Subject**2900RPM BOOM CONCERN****Model: X-TYPE 2.5L and 3.0L****Year: All****VIN C00344 to C83408****Section: 100-04****Noise, Vibration and Harshness****Summary**

Fitting an improved final drive damper in response to customer concerns of unacceptable 'boom' at 2900rpm engine speed.

Fig. 1

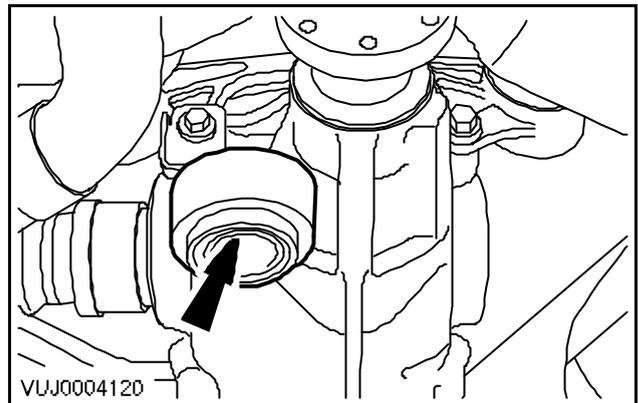
- 1 Raise vehicle on 'four-post' ramp.
- 2 Undo and remove damper-to-final drive casing securing bolt. (See Fig. 1)

- 3 Remove damper and place aside.
- 4 Remove one of the two damper spacing washers and discard.

Note: Only one damper spacer washer is required to space the damper away from the final drive casing.

- 5 Install and align new damper to final drive casing.
- 6 Install and tighten new damper-to-final drive casing securing bolt to 47.5Nm.
- 7 Lower ramp.
